**7000 Wisconsin Avenue  
Site Plan Submission  
Supplemental Narrative for November 20th Design Advisory Panel Meeting**

This Site Plan submittal is specifically focused on addressing all three of the DAP recommendations from the May 22nd meeting. Each of these recommendations is identified below with a summary of how the Applicant's Site Plan design addresses each comment as well as an analysis of the Proposed Development's compliance with the relevant Bethesda Downtown Plan Design Guidelines (the "Design Guidelines").

**7000 Wisconsin Ave  
Bethesda, MD**

**Design Advisory Panel  
Pre-Submission  
Preliminary Plan and  
Site Plan**

# ALLEY LEVEL IMPROVEMENTS: INTERIM CONDITION

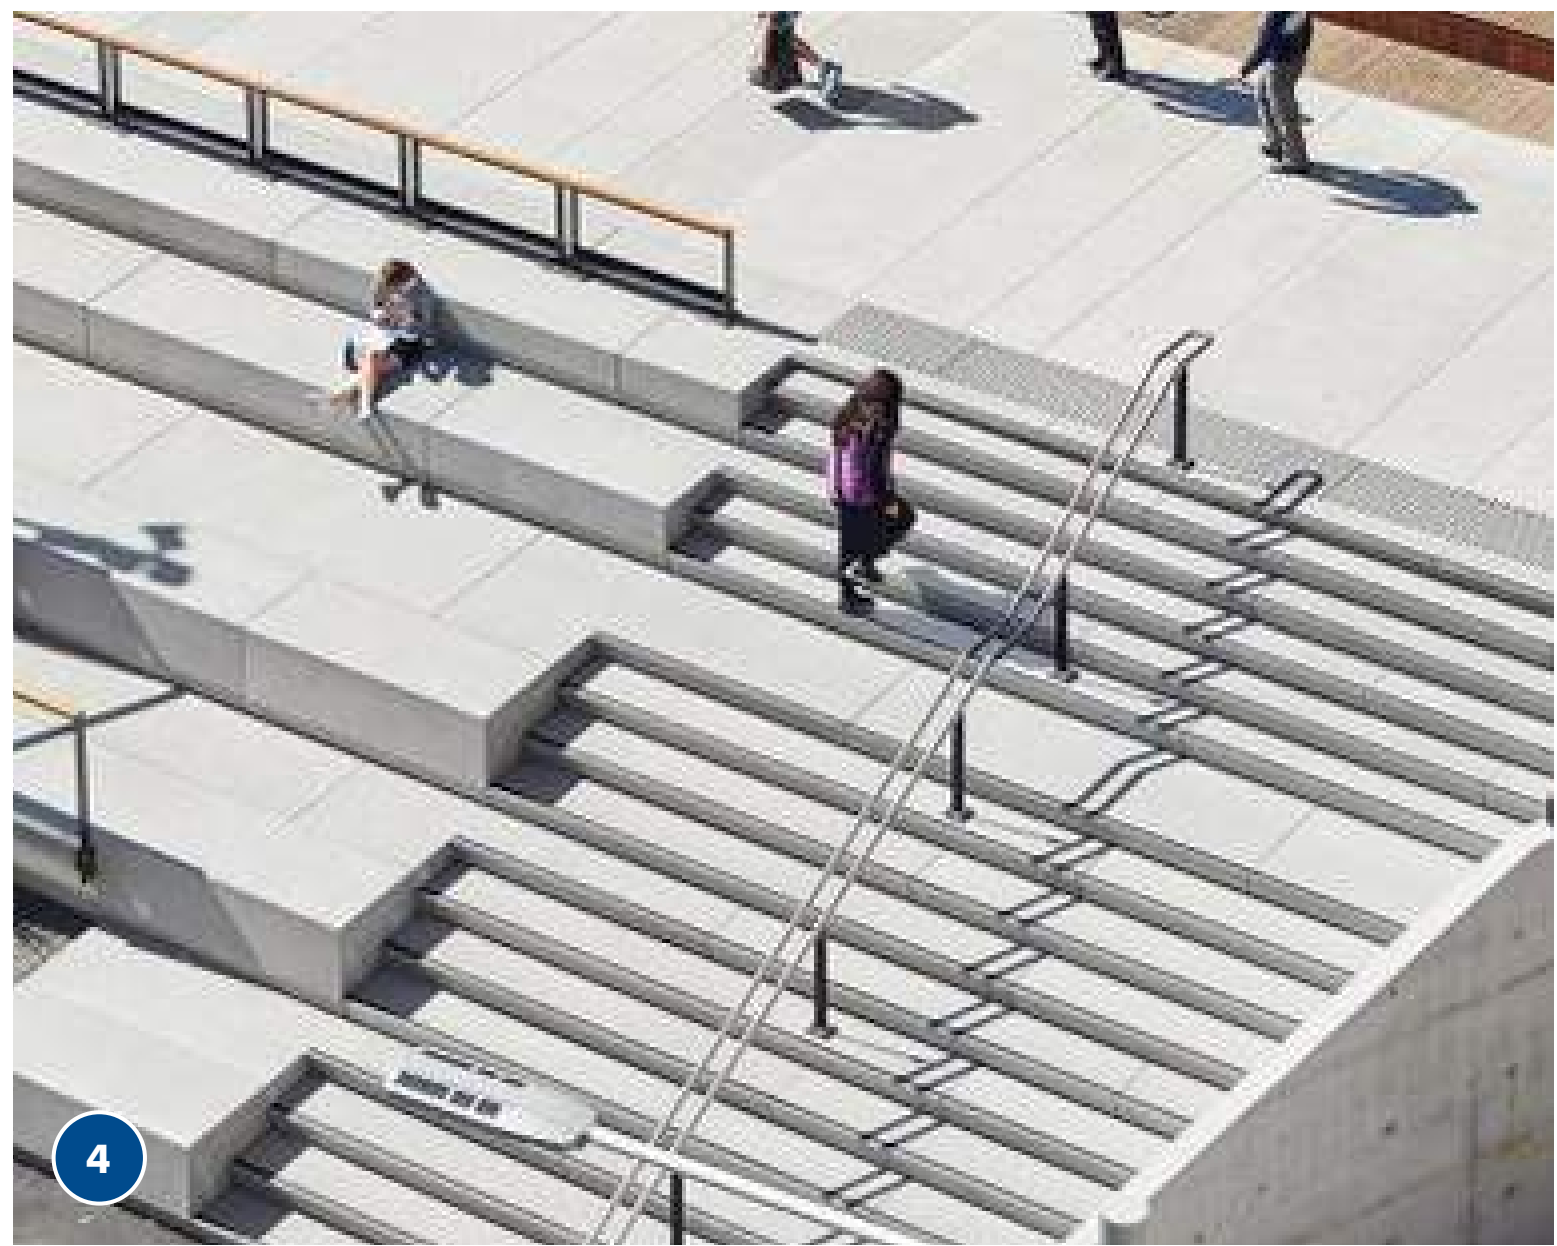
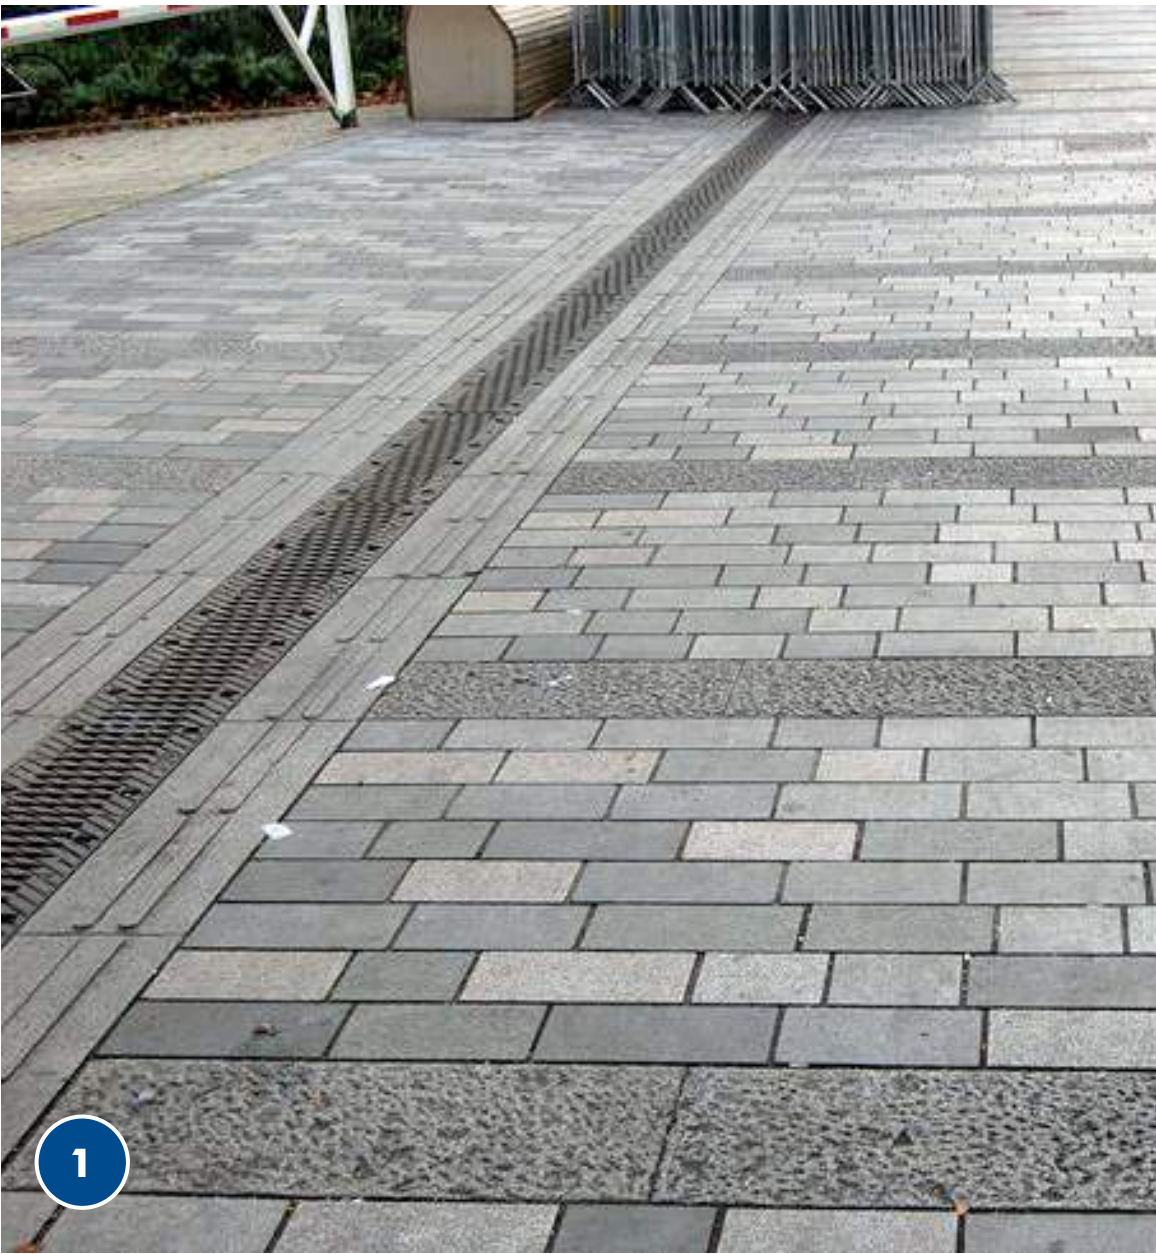
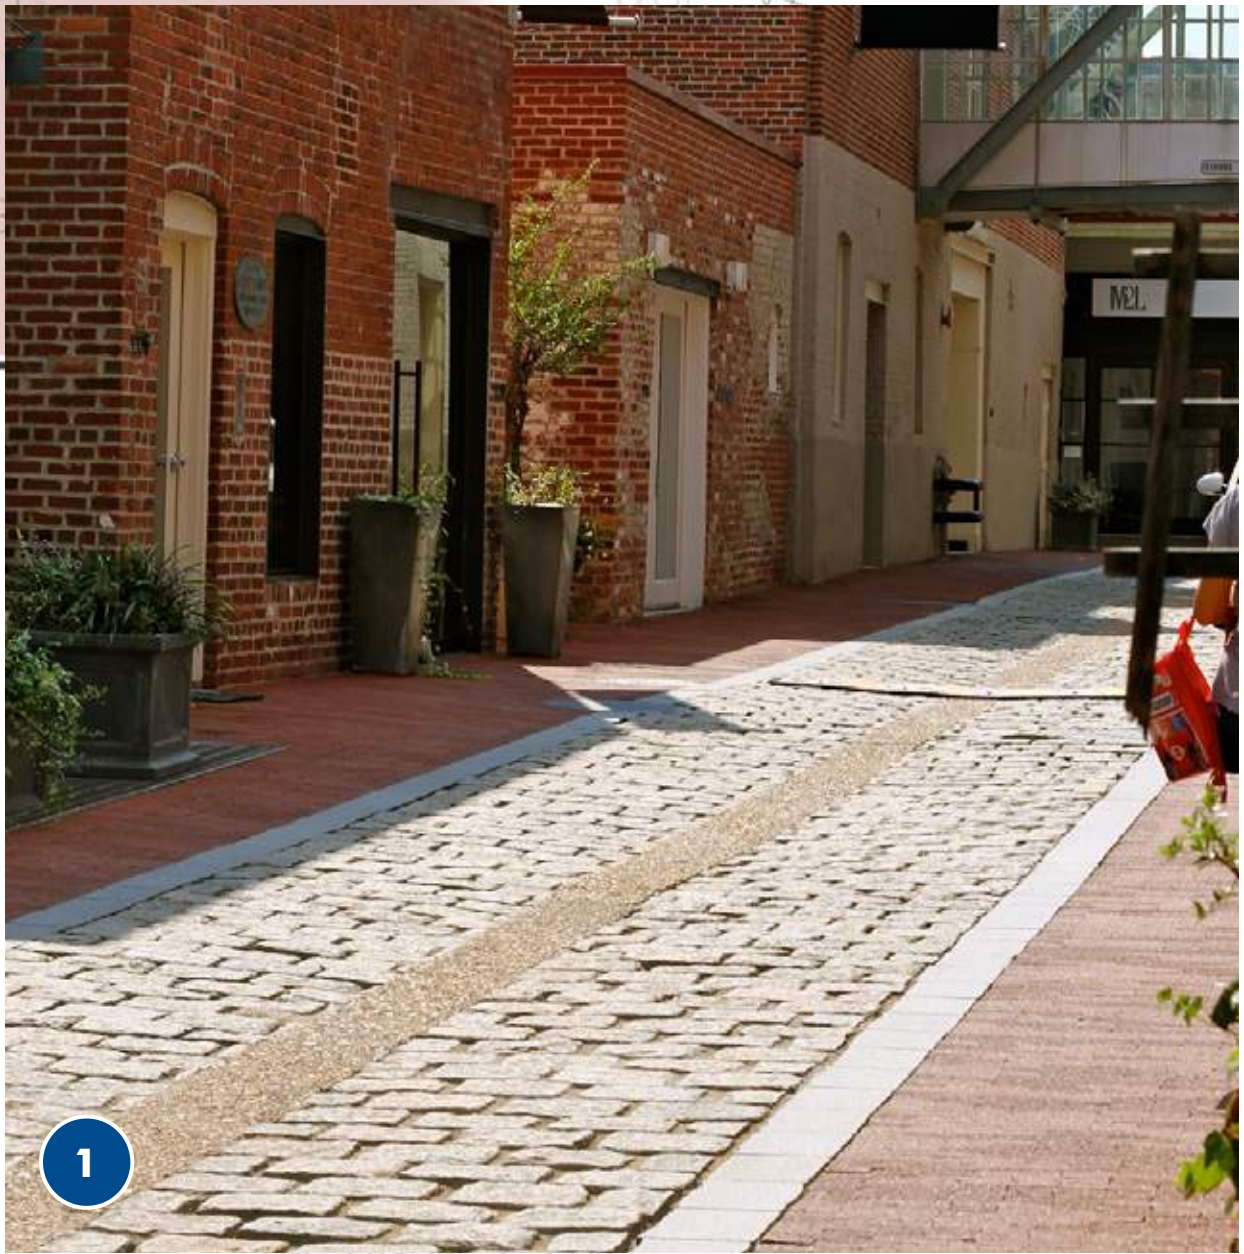
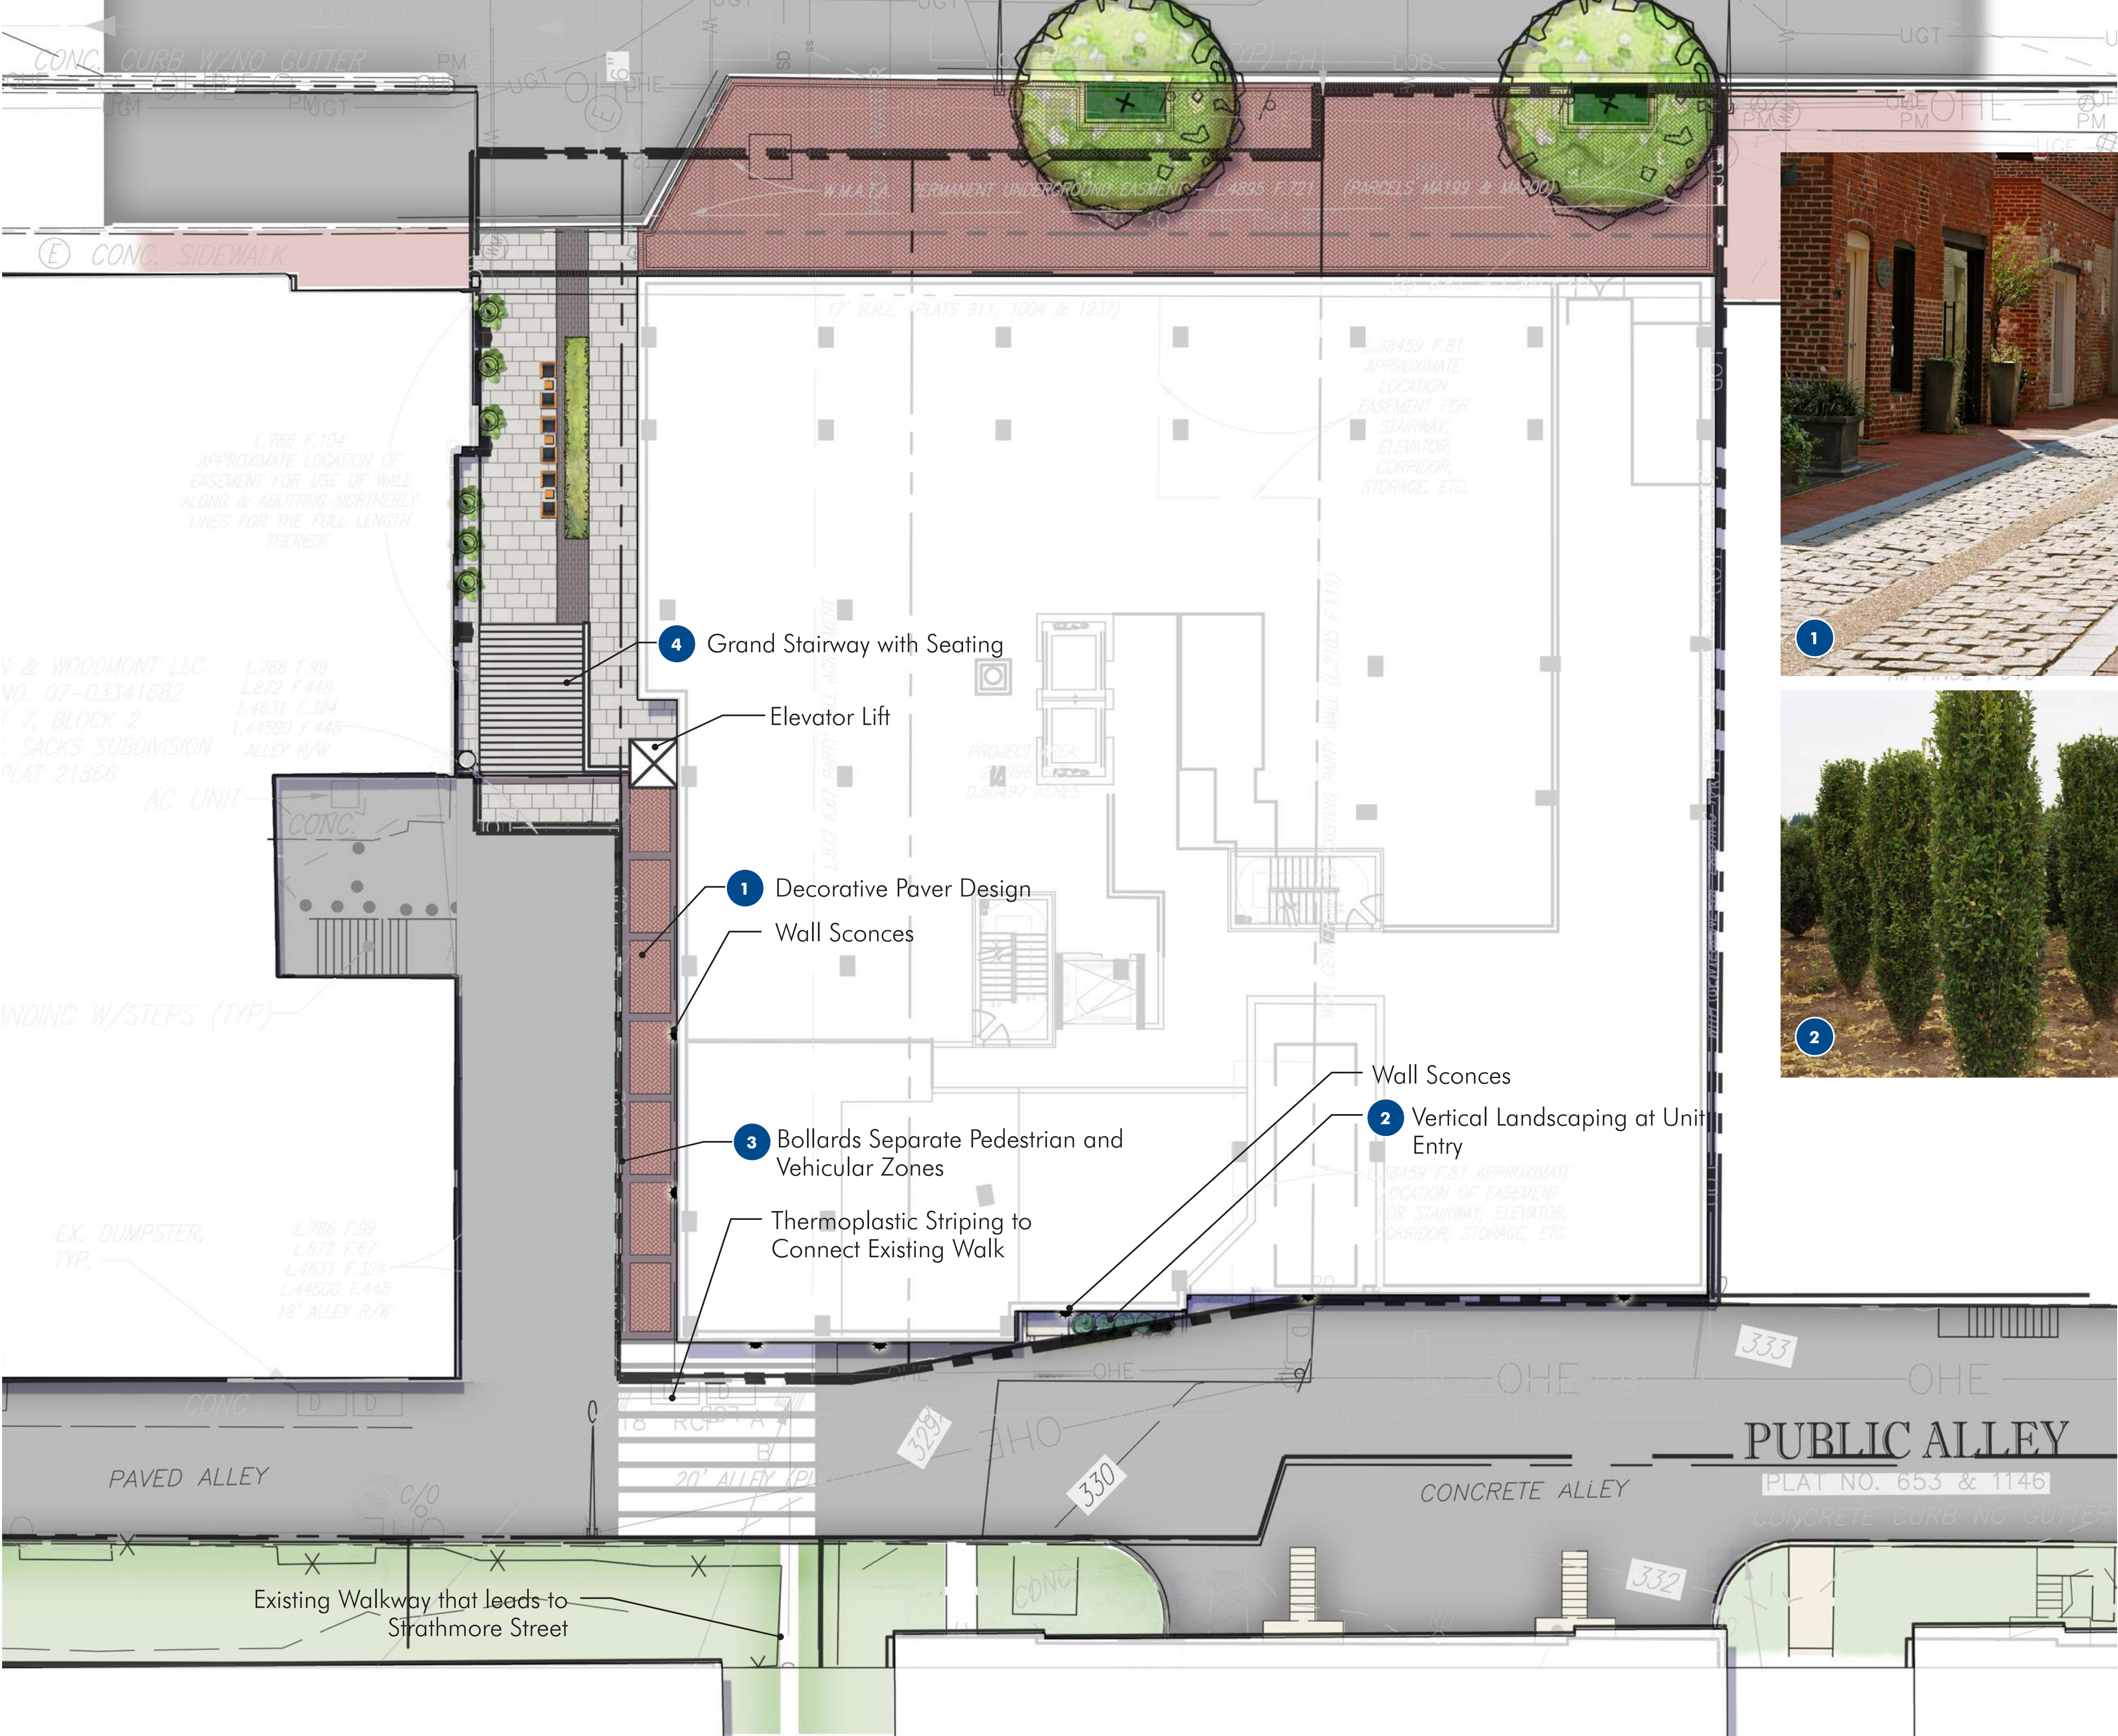
**DAP Recommendation 2.** Provide a clear drawing of the alley connections, dimensions and turning movements for trucks..

**Response:** The Applicant has coordinated the design of access and loading for the Project with the Montgomery County Department of Transportation (MCDOT) over the past year. The Applicant has conducted extensive technical and operational studies of the Public Alley during this time. In consultation with MCDOT, the Applicant has committed to providing a 4.5' building setback from the Public Alley to allow for a paved 29-foot alley section along the Property's frontage. In connection with this building setback from the Public Alley that will provide additional width in the alley, the Applicant will remove all dumpsters, utility poles and street lights along the Property's frontage and reconstruct this portion of the Public Alley through the redevelopment process. As reflected by the plan submittal identified below, the Project's design will accommodate

safe and efficient vehicular access and loading operations from the Public Alley. The following materials are included for informational purposes:

# WISCONSIN AVENUE STREETScape SKETCH

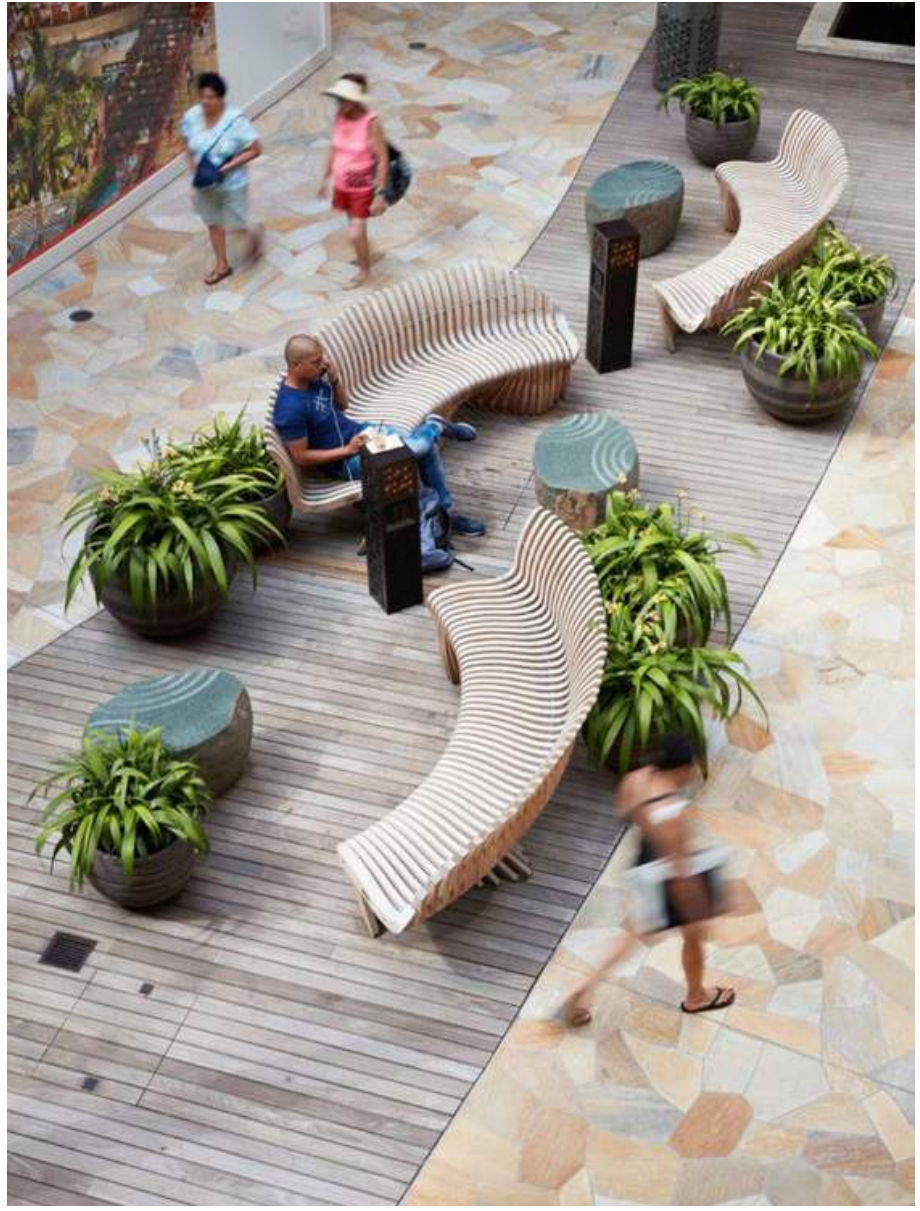
**DAP Recommendation 3.** Provide a landscaping plan to illustrate how the site design works.

**Response:** The Site Plan includes a detailed landscape plan to illustrate how the public realm will be enhanced through plantings and hardscape features along Wisconsin Avenue and the public through-block connection. The eastern portion of the public through-block connection includes hardscape and plantings that will create a pedestrian-friendly environment and complement the ground-floor retail that is proposed to wrap the through-block connection and Wisconsin Avenue streetscape. With respect to the western portion of the public through-block connection, the landscape plan reflects an interim condition that will be implemented with the Project. The adjacent property to the north (7008 Wisconsin Avenue) includes an 18-foot private alley that is subject to an easement benefitting the Property. The Applicant has coordinated with the adjacent property owner such that this private alley will continue to function as a loading space in the interim, but in the long-term, the Applicant will work with the adjacent property owner to expand the public through-block connection when it redevelops such that this portion of the public through-block connection will be in excess of 20 feet wide. In the interim condition, this portion of the public through-block connection (7 feet wide) will be separated by bollards to allow for safe and efficient pedestrian circulation. As illustrated in the interim condition and future conditions plan, the Applicant is proposing a grand stairway that will allow for pedestrian circulation from Wisconsin Avenue to the Public Alley, which accounts for the grade change from the front to the rear of the Property.
